Packet Guide
City of Charlottesville
Board of Architectural Review
Regular Meeting
August 18, 2026
Hybrid Meeting (In-person at Council Chamber and virtual via Zoom)

BAR #26-0015

915 East High Street, Tax Parcel 530247000

Project: Construction of multi-story, mixed-use building.

SHEET 7

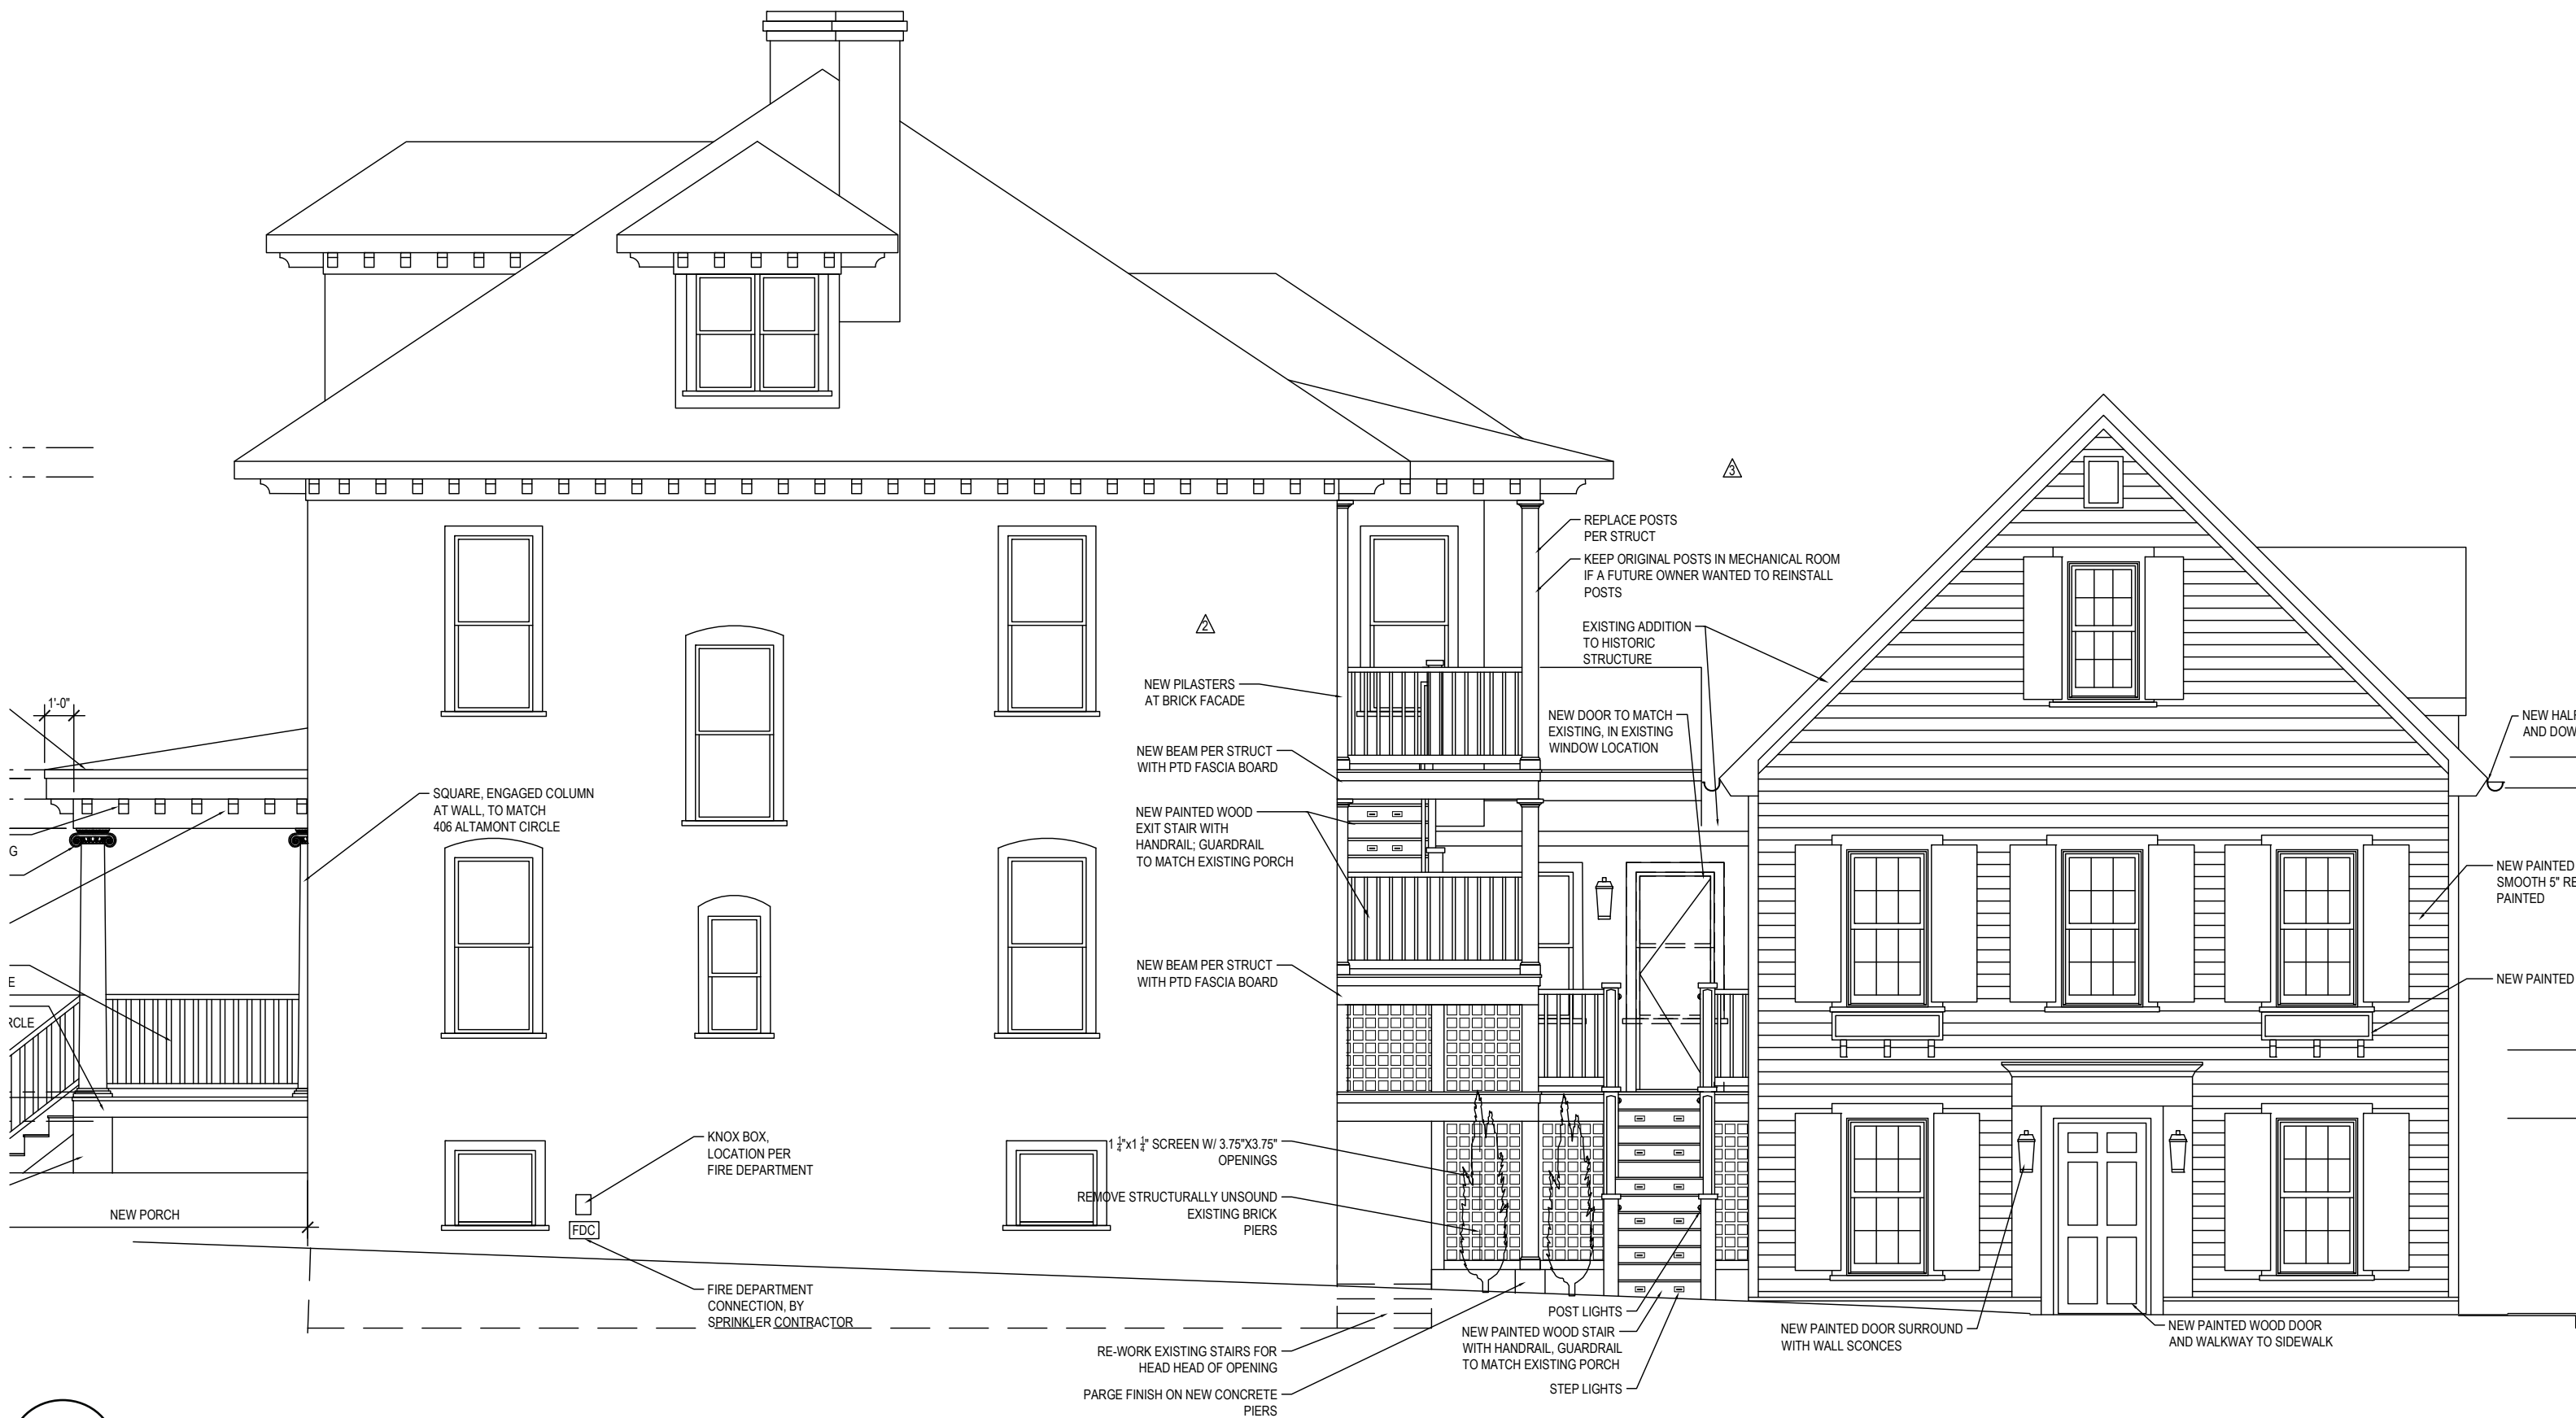
Mr. Timmerman – I had a question about your section on sheet 7, the bottom part. I am trying to figure out where the bottom beams cut through.

Mr. Batman – It starts with the detail on the top of this column and up to the port track.

Page 16

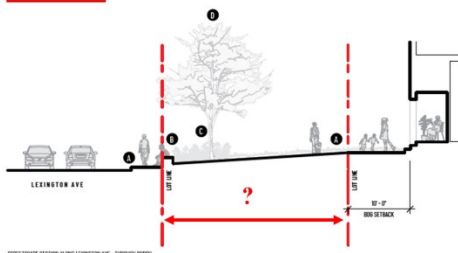
Pg 16. Show the dimension for the wide setback. Even if it's a range due to site variation.

Page 17

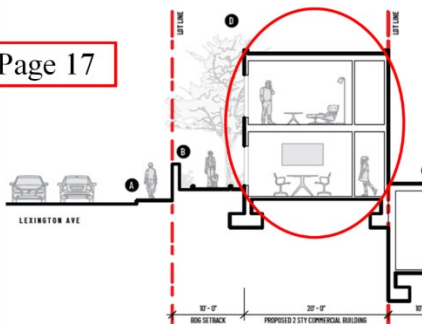
Page 17: Is the two-story structure included for review or shown only as a spatial placeholder?

Page 26

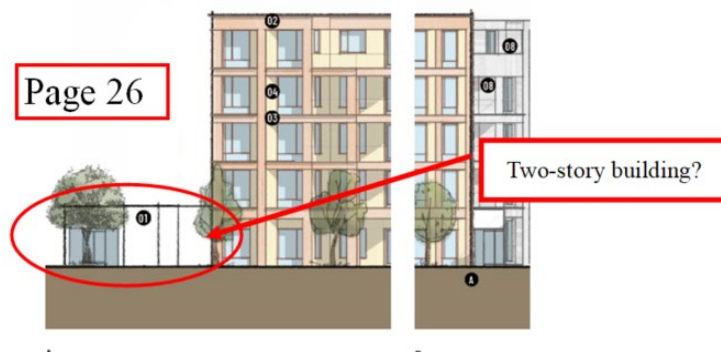
Page 26: Notation for the wood siding on what I assume is the two-story structure. Why is it single-story here?

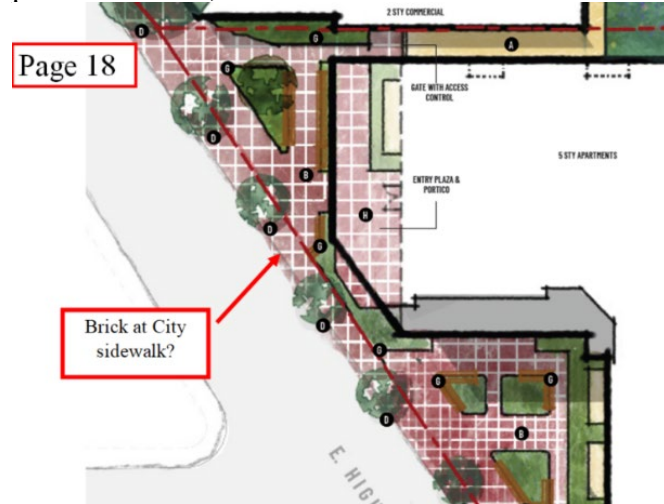
Page 18: Brick walk is shown at the street, in lieu of concrete sidewalk. BAR will not have a problem with it, but will ask if Public Works is OK with it.

Page 19

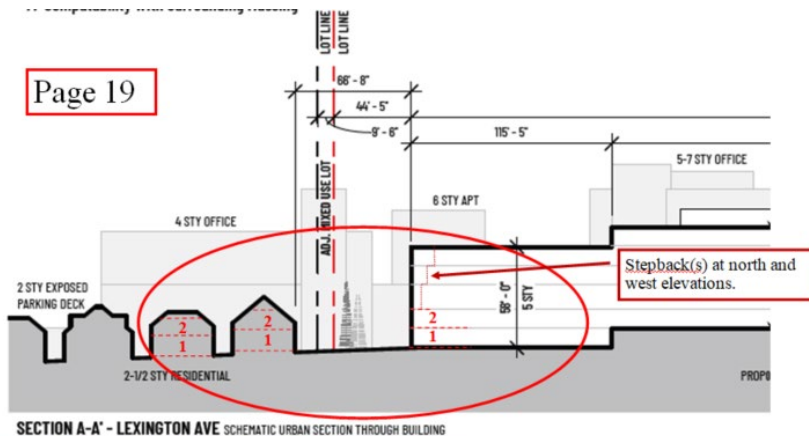
The BAR may accept the overall height, but the guidelines suggest the floor heights of the new correlate with the floor heights of the adjacent houses.

If I had to guess, the BAR will want some reduction at the NW corner. Either a stepback or stepbacks so the building is not five-stories immediately adjacent to the SFDs on Lexington.

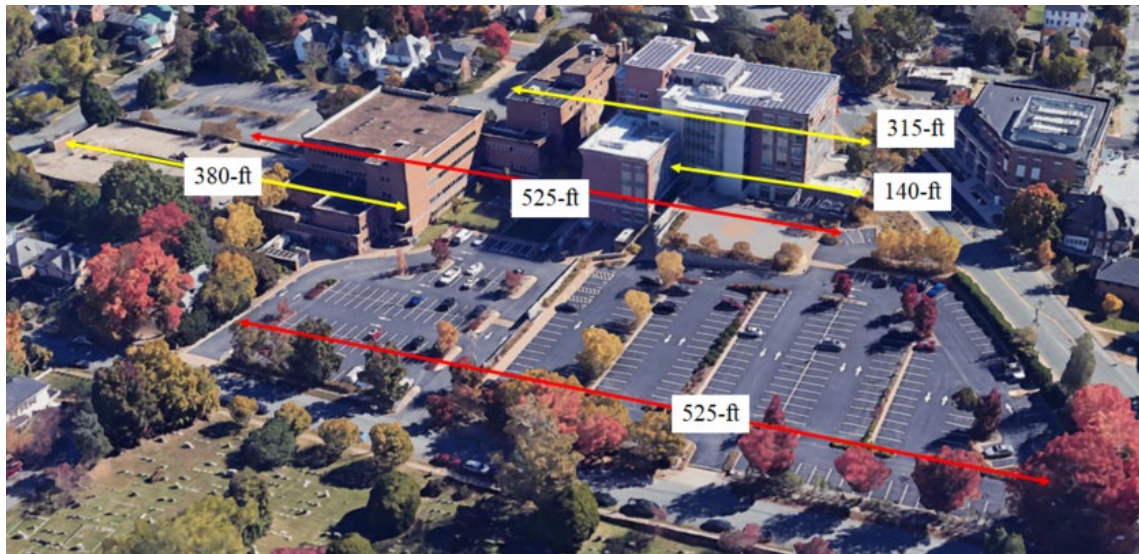
A red arrow points to a location on the plan, labeled 'Elevation ?'.

Clarify the retaining walls at the west elevation.
